## ON-SITE SEWAGE DISPOSAL SYSTEM HOWARD COUNTY HEALTH DEPARTMENT BUREAU OF ENVIRONMENTAL HEALTH

SUBDIVISION: Clarksville Overlook LOT NUMBER: 35

<b>MORRIS &amp; RITCHIE ASSOCIATES, INC.</b> ENGINEERS, ARCHITECTS, PLANNERS, SURVEYORS, & LANDSCAPE ARCHITECTS 3445-A Box Hill Corporate Center Drive Abingdon, Maryland 21009 (410) 515-9000 Fax: (410) 515-9002	SITE AND GRADING PLAN FOR <b>CLARKSVILLE OVERLOOK</b> (A.K.A. MACBETH FARMS) LOT 35 #12815 MACBETH FARM LANE 4TH ELECTION DISTRICT HOWARD CO., MARYLAND
	SCALE: 1"=50' DATE: MAY 3, 2007 DRAWN BY: T.B. DESIGN BY: T.B. REVIEW BY:	JOB NO. 14948

**AS-BUILT FOUNDATION PLAN**  
 MACBETH FARMS  
 12815 MACBETH FARM LANE  
 LOT #35  
 PLAT M.D.R. NO. 18791  
 5th ELECTION DISTRICT, HOWARD COUNTY, MARYLAND  
 FOR: N.V. HOMES

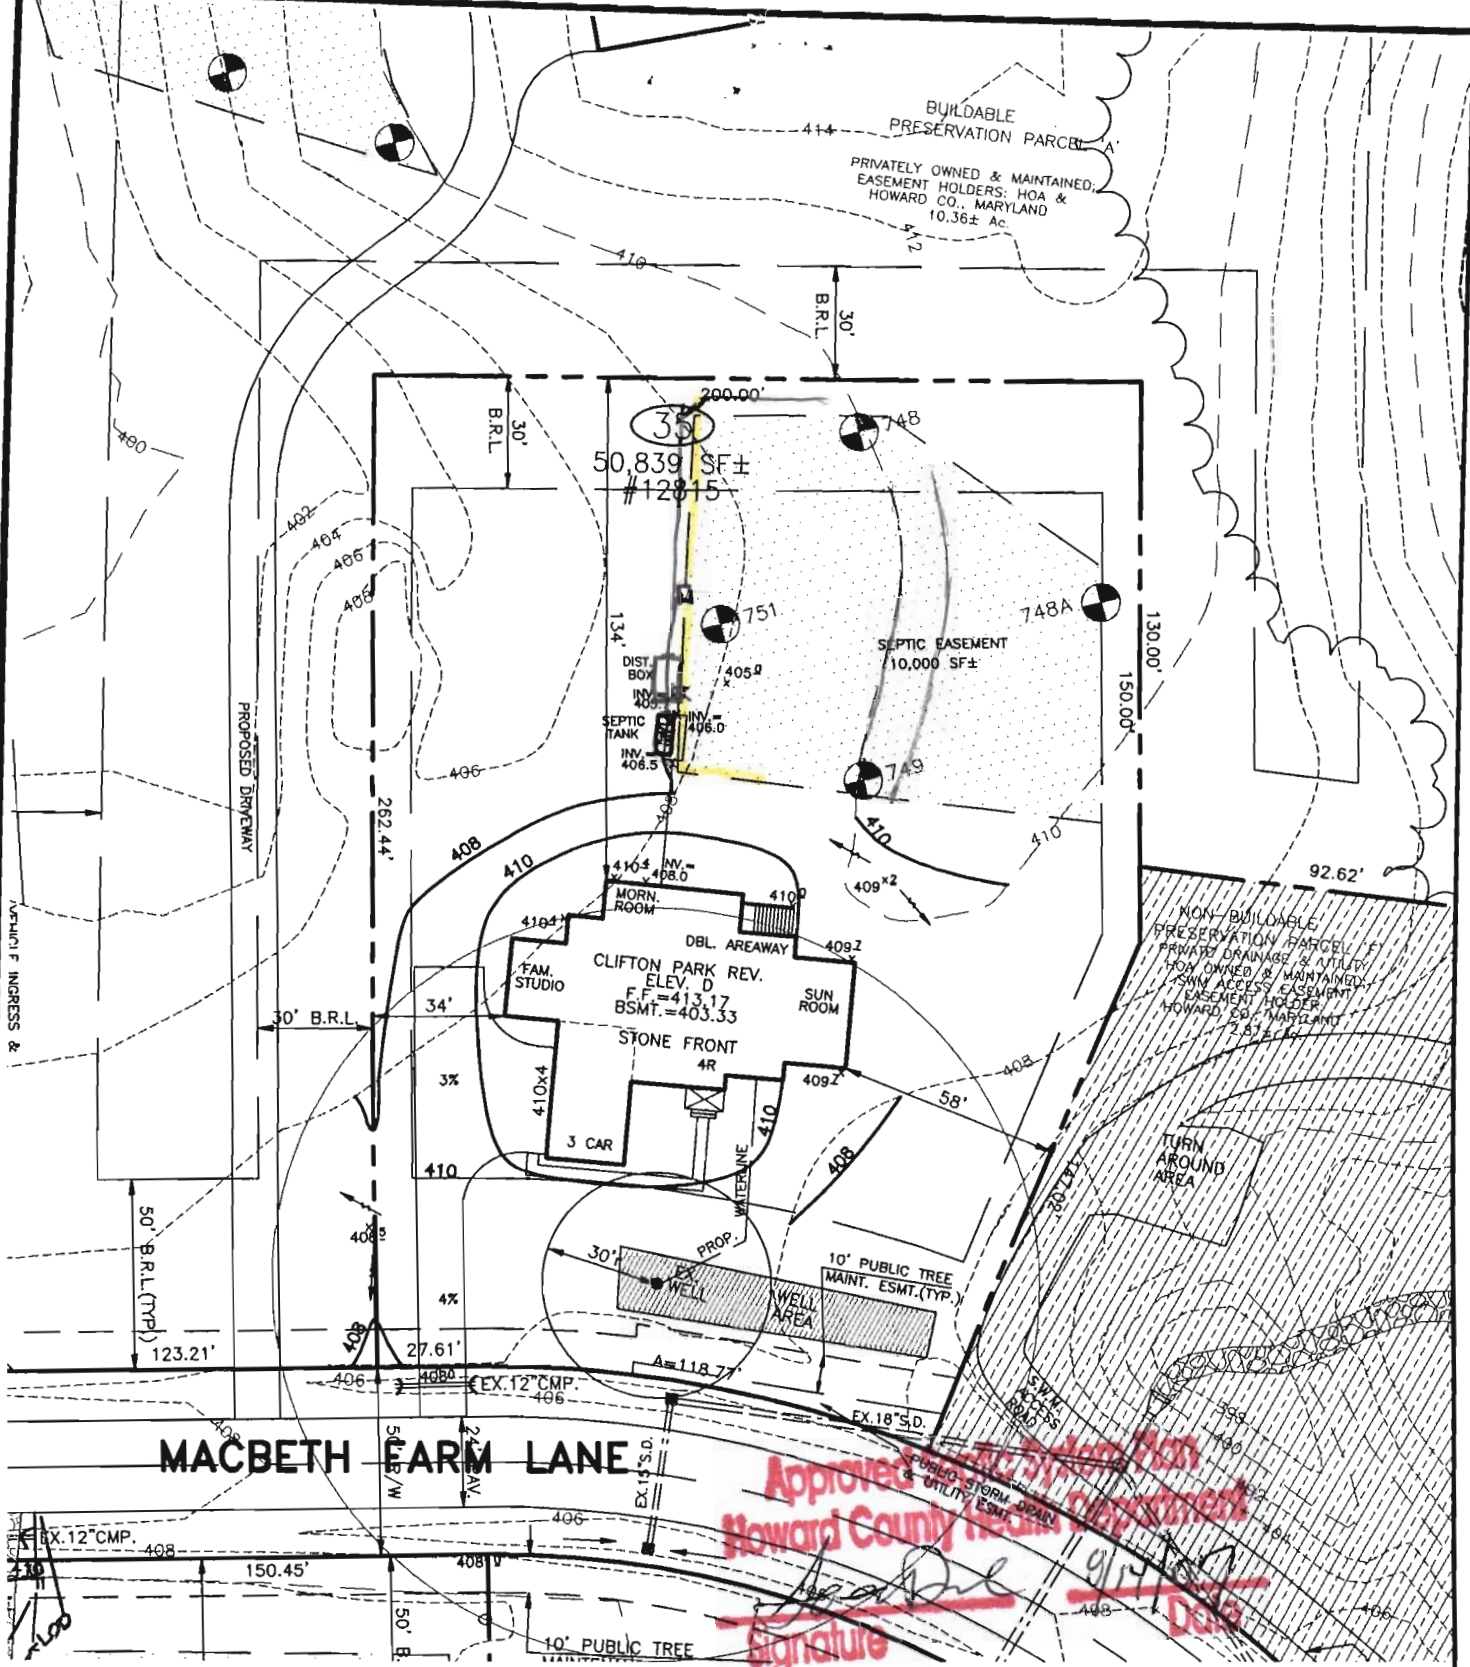
PRE-CONSTRUCTION 10/26/07 Pumped system required. Place the distribution box near perc. test hole 748 and install  
 INSTALLATION stall a 100' and 94' trench on contour towards the house. (BB) 11/6/07 Tanks installed. Trenches installed. Need rear baffle in primary tank. Distribution box appears to be on neighbor's property. Asked installer to move box. Also need pump and alarm test and manhole risers. (BB) 11/8/07 Need pump and alarm test. (BB) Distribution box moved. (BB) 12/2/07 Pump and alarm working. (BB)

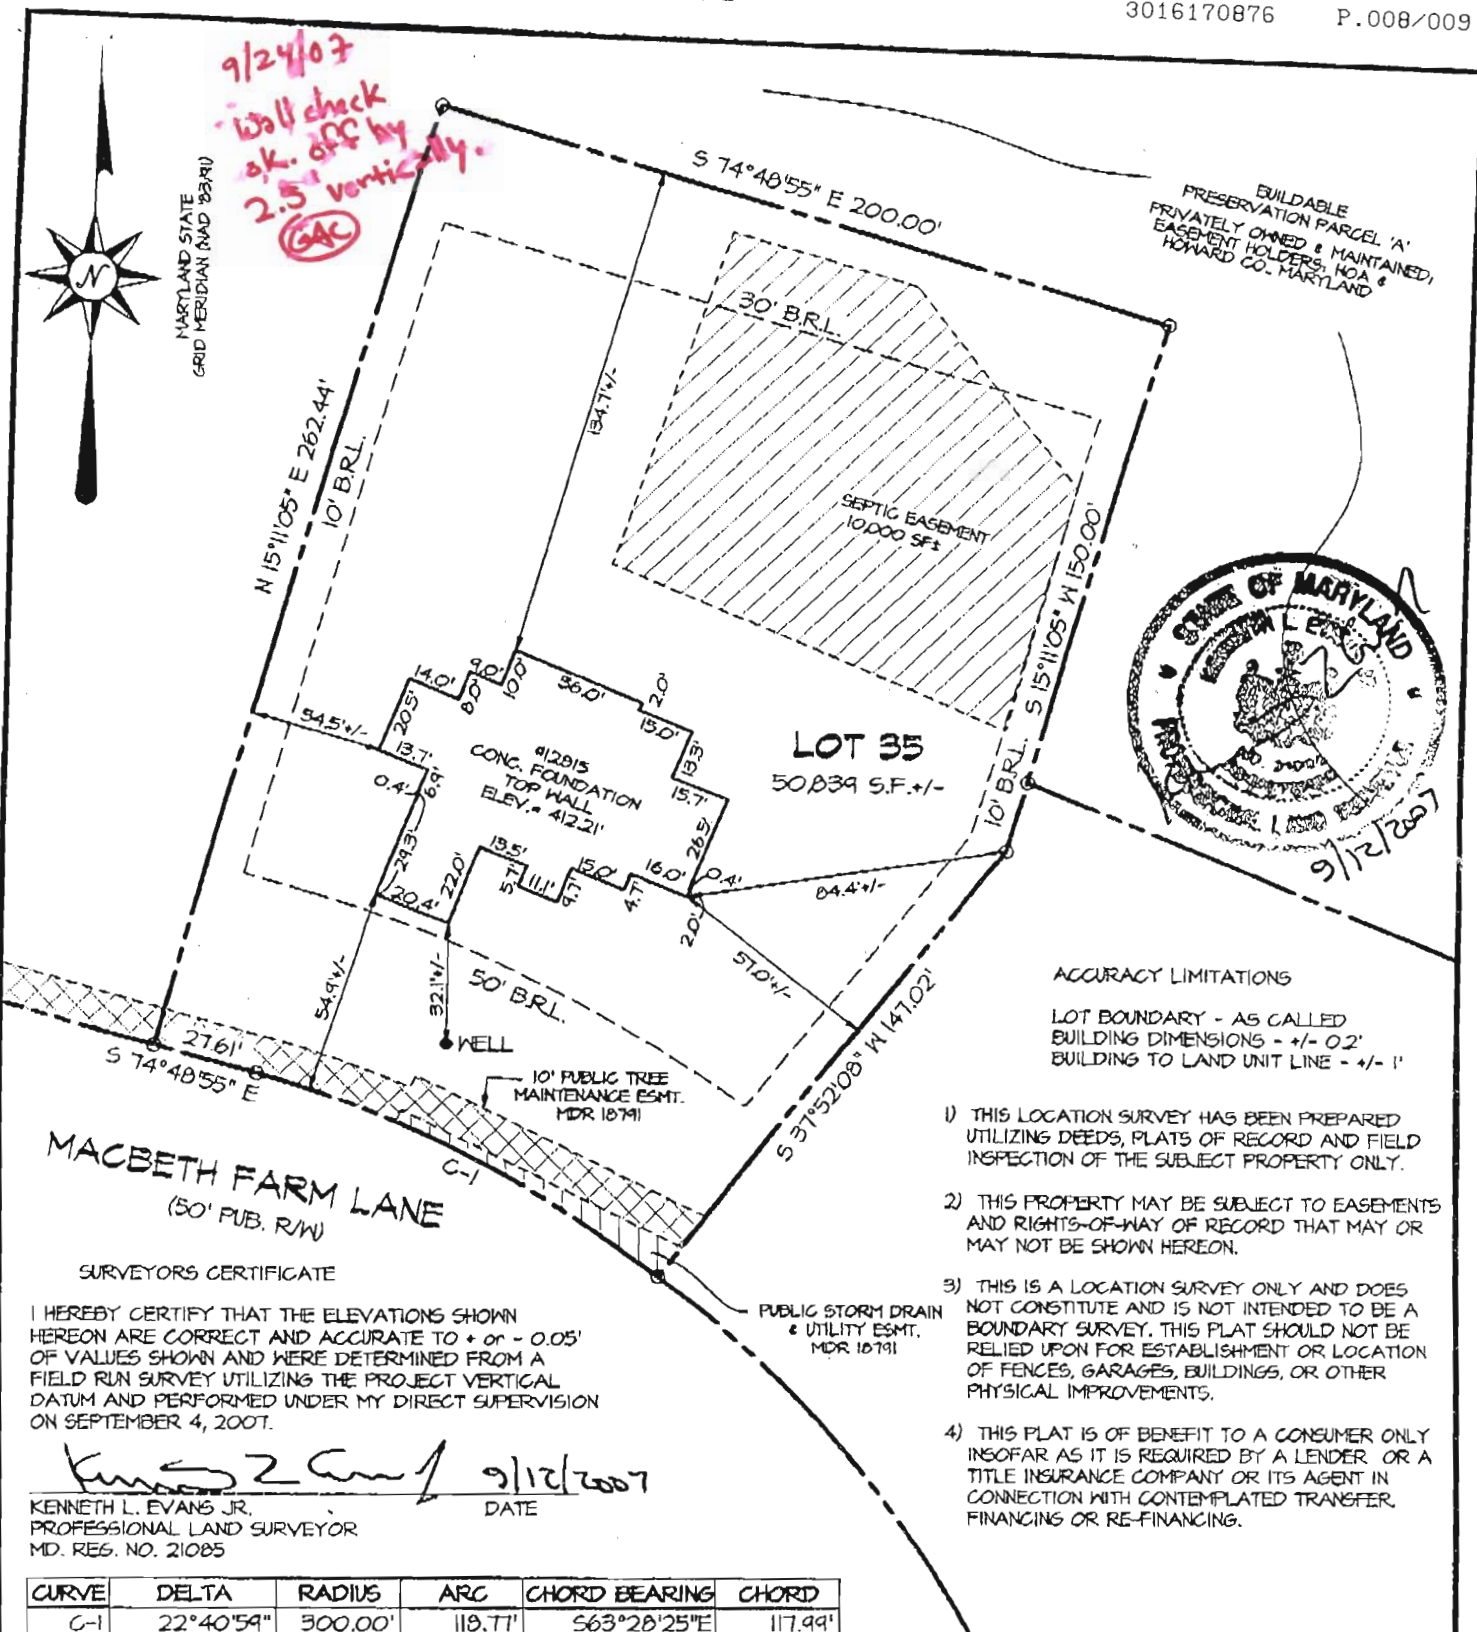
9/24/07  
 Walk check  
 o.k. off by  
 2.5' vertically.  
 (GAC)
